# Access Compliance Report

## Public Rights-of-Way

### (Curb Ramps)

Intersection ID: 6911	Main Street: CINDY_LN	Cross Street: CINDY_PARK_DR	Location: SW
ADA ID: AD246EF5F6C7	Ramp Type: Perp	Initial Pass/Fail: Fail	Overall Compliance: No
		Severity Score: 10

#### Codes/Mitigation Info/Possible Solution

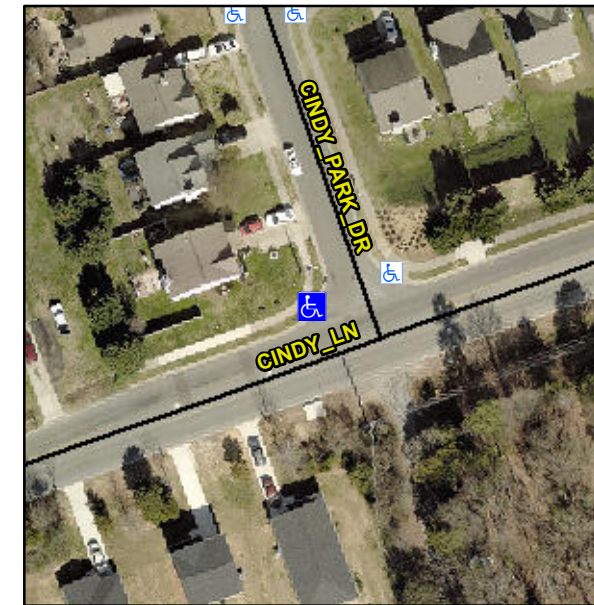
**Not Found, R304.5.1, R304.5.3**

Compliance	Description	Data	Compliance	Description	Data
N/A	Ramp Length (in)	50.5	Yes	Ramp Slope (%)	7.1
No	Ramp Width (in)	46.0	No	Ramp XSlope (%)	4.7
N/A	Flare Type LT	N/A	N/A	Flare Type RT	N/A
N/A	Flare Slope LT (%)	N/A	N/A	Flare Slope RT (%)	N/A
N/A	Flare Traversable LT?	N/A	N/A	Flare Traversable RT?	N/A
N/A	Landing Length (in)	N/A	N/A	DWS Provided?	N/A
N/A	Landing Width (in)	N/A	N/A	DWS Contrast?	N/A
N/A	Landing Slope (%)	N/A	N/A	DWS Length (in)	N/A
N/A	Landing X Slope (%)	N/A	N/A	DWS Full Width?	N/A
N/A	Landing Curb? (Y/N)	N/A	N/A	DWS Offset (in)	N/A
N/A	Shared Landing?	N/A			
N/A	Gutter Ponding?	N/A	N/A	Gutter Slope (%)	N/A
N/A	Gutter Lip Ht (in)	N/A	N/A	Gutter X Slope (%)	N/A
N/A	Painted X Walk1?	No	N/A	Painted X Walk2?	N/A
	X Walk 1 Direction	To E		X Walk 2 Direction	N/A
N/A	X Walk 1 Width (in)	N/A	N/A	X Walk 2 Width (in)	N/A
	X Walk 1 Slope (%)	1.4		X Walk 2 Slope (%)	N/A
	X Walk 1 X Slope (%)	1.8		X Walk 2 X Slope (%)	N/A

**Remove & Replace Entire Ramp.**
